Franklin Municipal Planning Commission

Thursday, February 26, 2015

DOWNS BLVD SUBDIVISION, SITE PLAN, SECTION 1, LOT 20
FRANKLIN MUNICIPAL PLANNING COMMISSION 2/26/15

17. HVAC

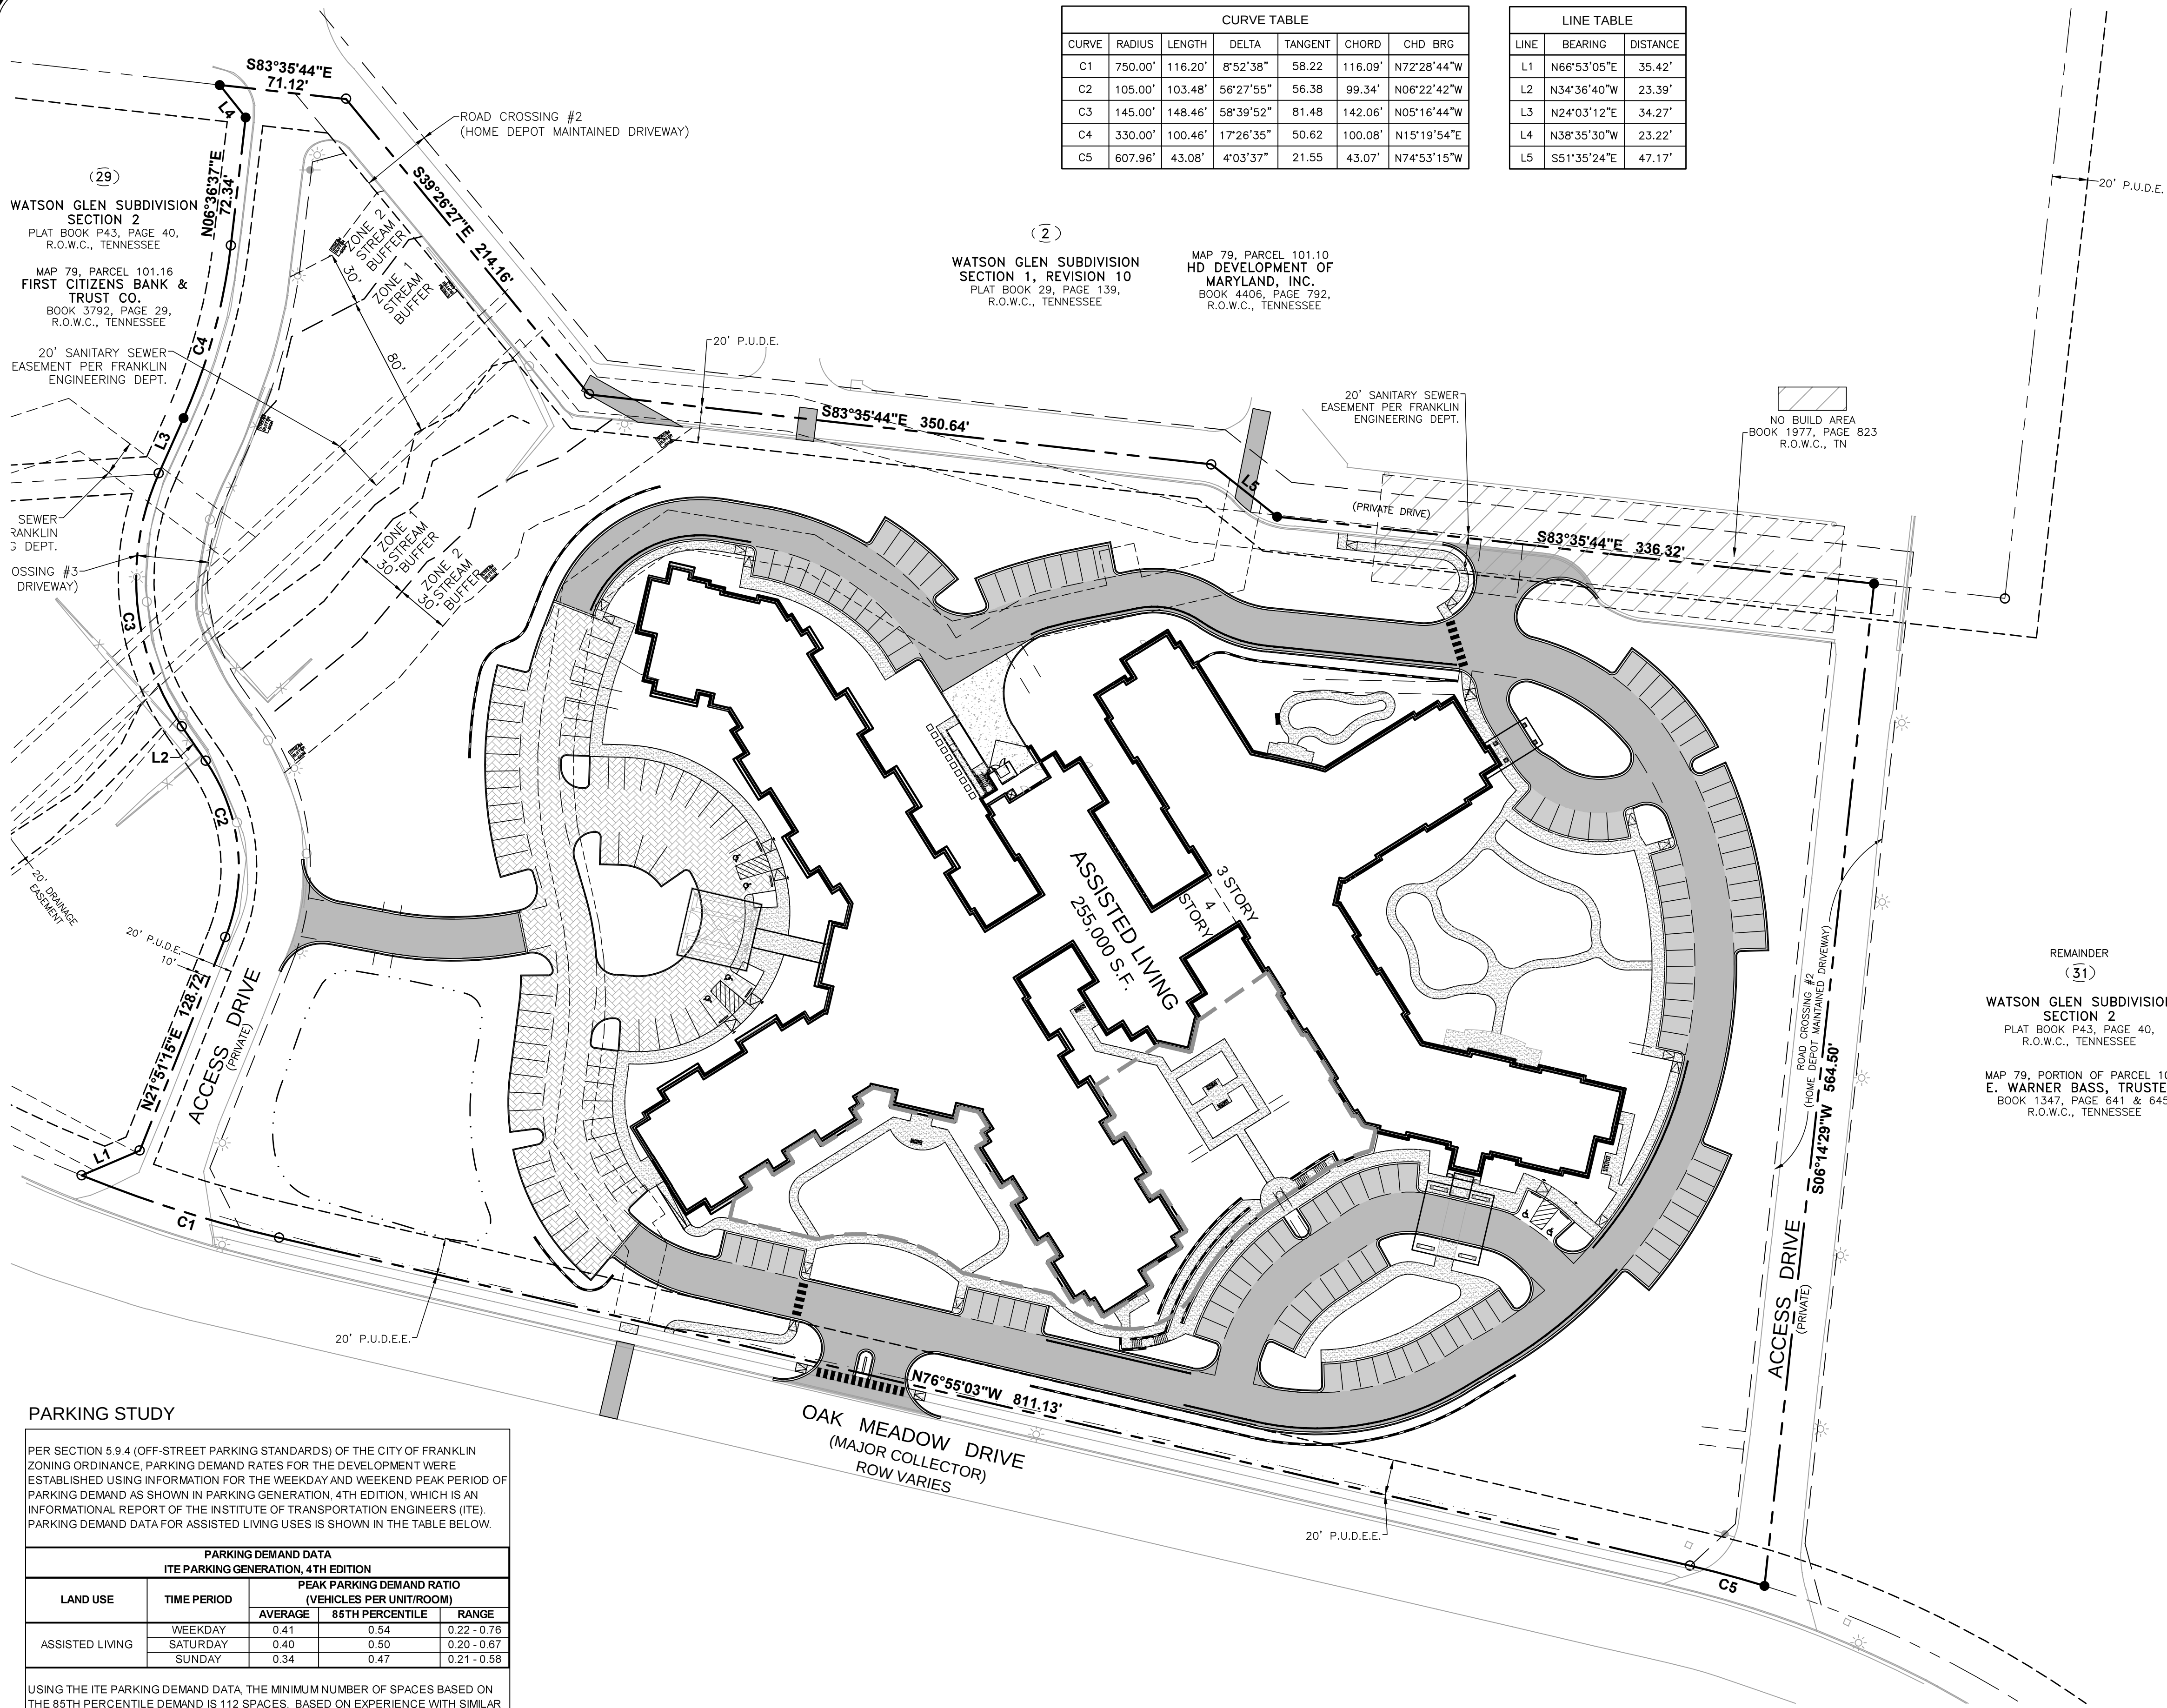
- Provide additional screening of the HVAC from all directions. Also please clarify that these are the only mechanical units proposed.
